1 Reset Domain Crossing - Basics

2 Reset Definitions

5 RDC Analysis

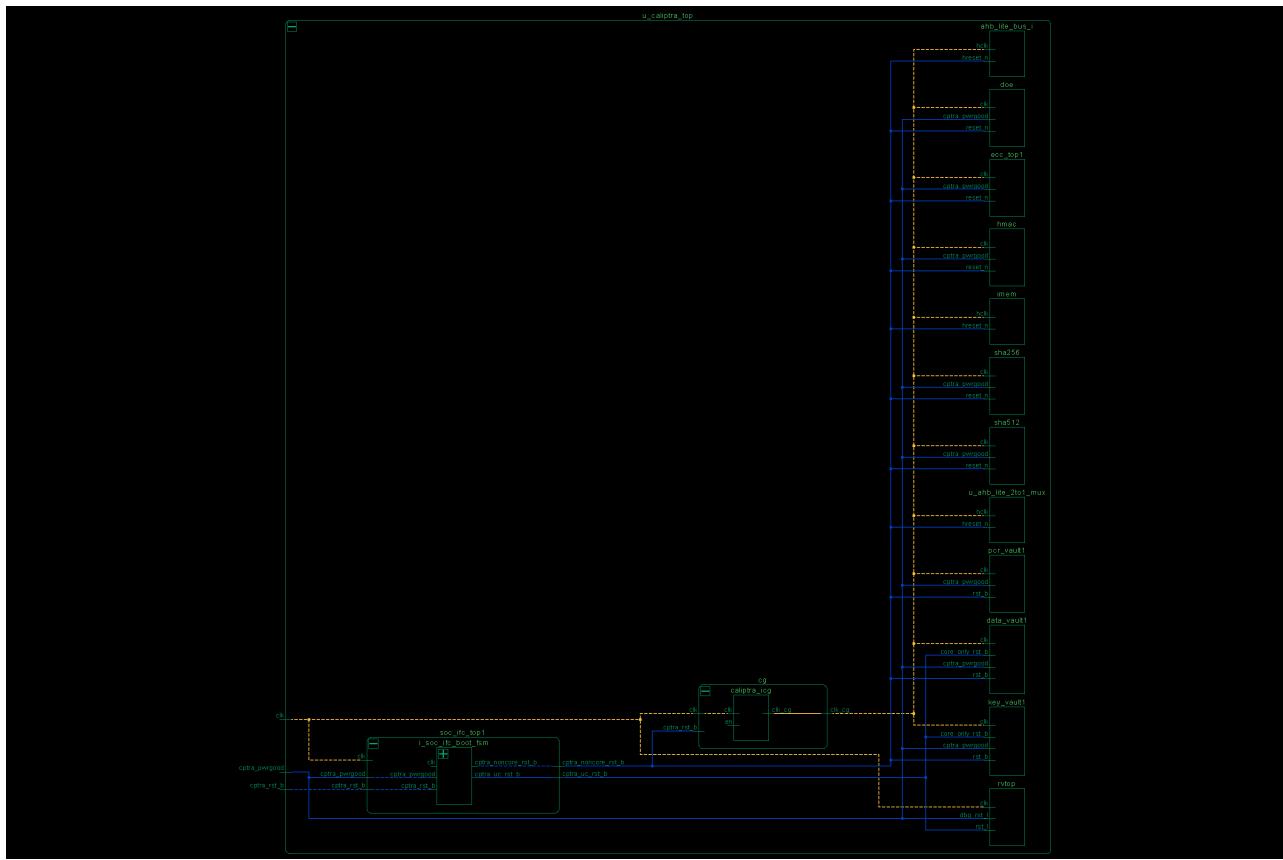
Upon analyzing the RDC violations reports, we found that the following modules/instances receive CPTRA_PWRGOOD, CPTRA_RST and NON_CORE_RST and the flops on these resets inside these blocks are destination flops in RDC crossings.

Two new signals are added in the design to gate the clocks of the destination modules:-

Boot FSM

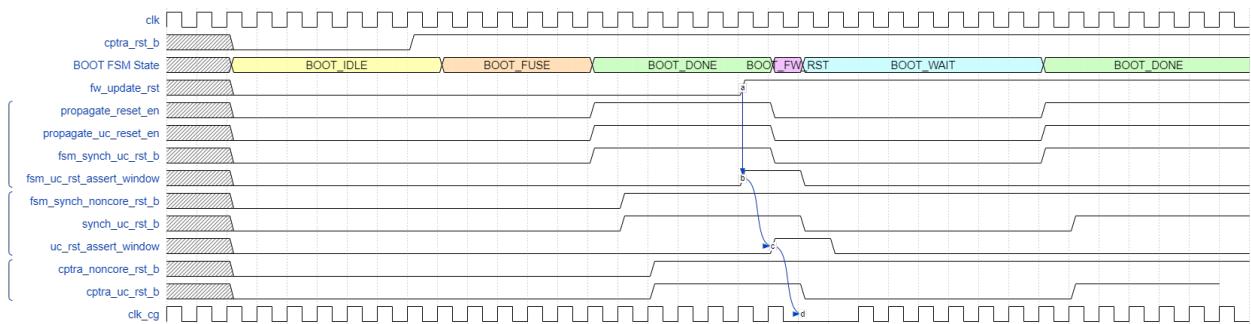
- ***uc_rst_assert_window*** - This signal is driven by Boot FSM just around the firmware reset assertion window as shown below

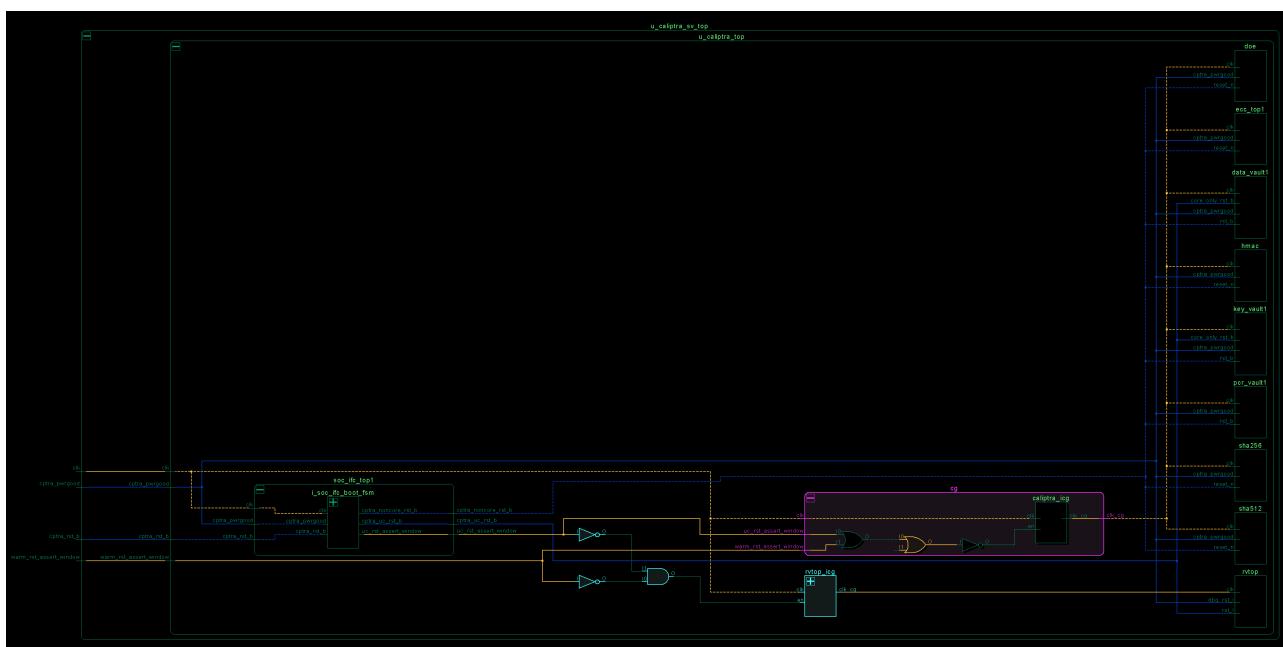
To achieve the above timing, the following changes are done to BOOT FSM (This needs to be reviewed by Caliptra designers)

- **uc_rst_assert_window** is set to 1 in **BOOT_DONE** state if **arc_BOOT_DONE_BOOT_FWRST** is set
- **uc_rst_assert_window** is set to 1 in **BOOT_FW_RST** state

In addition to above, a new state is required to be introduced after `BOOT_FW_RST` so that `uc_rst_assert_window` is kept at 1 for at least two cycles after UC reset is asserted. This is not true as of today and need FSM update.
